GISBORNE WASTEWATER NETWORK – OVERFLOW DISCHARGES: REGULATORY REF: DW-2020-109732-00/WD-2020-109733-00

Further S92 Response 21 April 2021

Pipe Height: 301.00

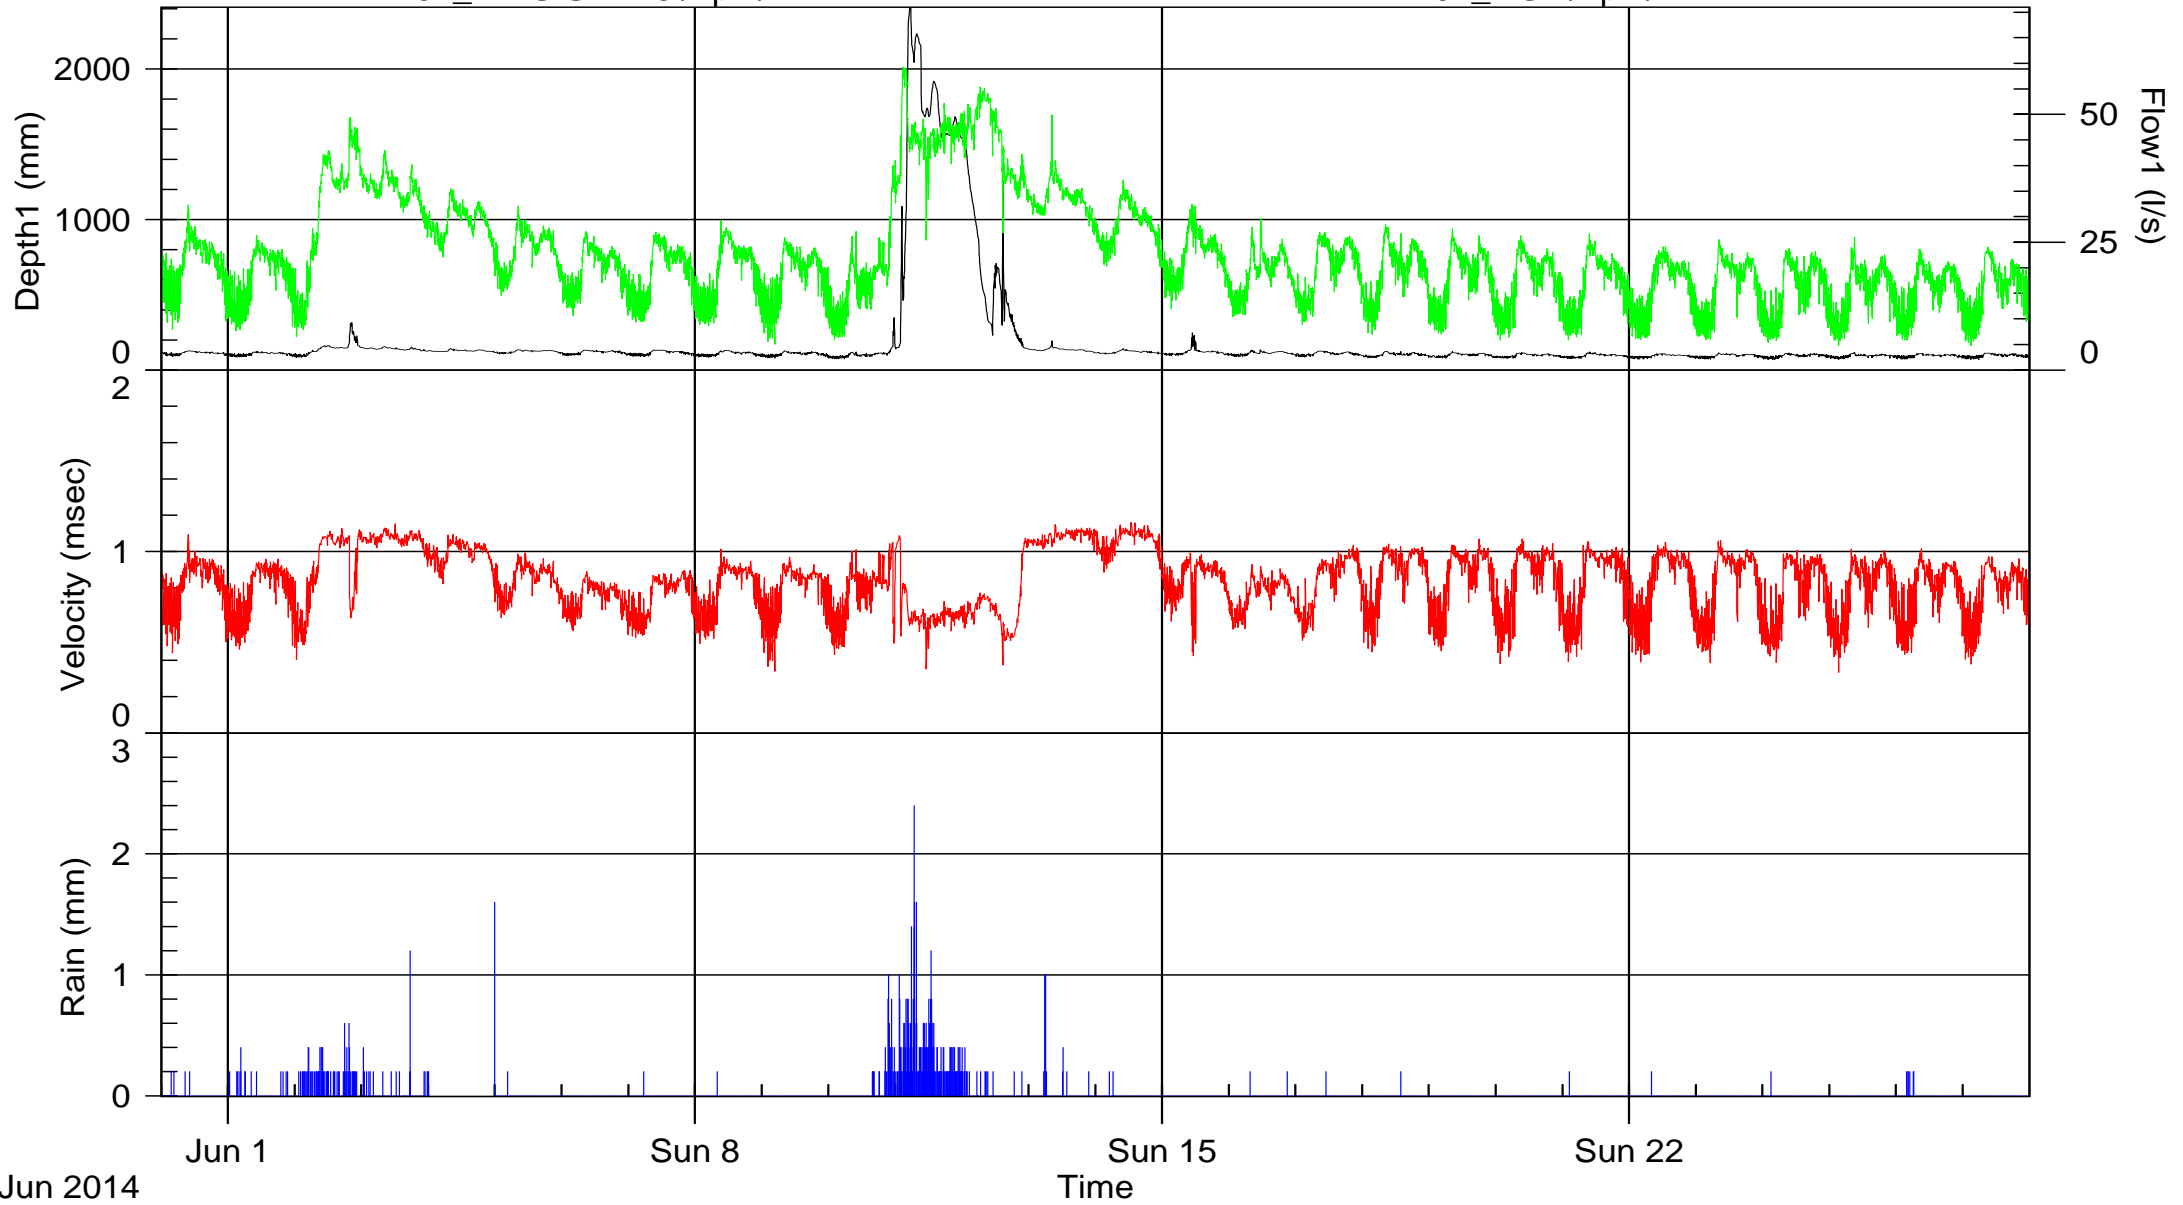
<p>upstream wastewater network including pump stations and reference (from the Mott Macdonald gauging report) which locations/hydrographs one(s) show the fast response to direct inflow?</p>	<p>We have also extracted flow monitoring information from the Mott Macdonald report for June 2014 (Attachment B) to facilitate review of the network flow monitoring across the monitoring sites. As can be seen from this extract, all of the monitoring sites show rapid response to heavy rainfall. Some sites to the south of the Taruheru River (eg APNISM135, DISRSM125 and LYTTSM075) also show the influence of overflow valves being opened from 11 to 12 June 2014.</p>
<p>b. Can the applicant provide a map/schematic that show areas of known property flooding referenced in the original application, page 223, see Figure 3-2 from the CH2M Beca Modelling Report, 2017. How does this compare to the nodes identified as flooding in the 2yr-ARI map (Figure B2) in the Beca modelling report.</p>	<p>A map showing indicative property ponding is provided below.</p> <p>The 'Ponding Likelihood' layer predicts where water is likely to pond on a property, based on a number of GIS layers that have been aggregated through a weighting process. These GIS layers include our stormwater flood model, depressions layer, and a Rain on Grid model.</p> <p>Ponding can be affected by many factors, e.g. fences on a property may divert flows, private stormwater sumps and pipes may drain areas, and soil conditions may allow for water to seep into the soil quicker than modelled. The data is also relevant to information available at a specific point in time, and things may have changed over time. Therefore, this layer is viewed as a guide only, as site conditions could be different.</p> <p>The modelled information is based on geospatial modelling, is for indicative purposes only. Council also uses records of actual flooding (surveys and Requests for Service received) and undertakes property inspections / investigations to validate whether or not there are actual effects, and whether or not stormwater drainage improvements (public or private) are required to mitigate the risk of ponding.</p> <p>The nodes identified in Figure B2 have been overlain on the Ponding Likelihood' layer. However, the location of property flooding in heavy rainfall will not necessarily correlate to the location of wastewater overflows from manholes.</p> <p>While property flooding is considered a primary cause of rainwater entering the wastewater system, properties that experience wastewater overflows will not necessarily also be the properties that experience rainwater flooding. Property</p>

<p>c. Can the applicant please provide a <u>model calibration report</u>. This should include a comparison between predicted/modelled flows and gauged data and demonstrate how well the model performs. This is required to determine the level of confidence in the modelling results (and subsequent conclusions).</p>	<p>No specific calibration report was produced. The flow gauge data and model graphs were part of the calibration process as is standard practice. The model aims to reflect the AWT flow gauging report that shows rainfall and the resultant wastewater flows that occur very quickly afterwards. As indicated in our previous response, the flow gauging sites were selected with a key aim of calibrating the model to predict overflow performance. The flow records show rapid and substantial increases in wastewater network flows associated with rainfall events and this is a clear demonstration of the result of direct stormwater inflow (Fast Response), which is replicated in the wastewater model.</p>
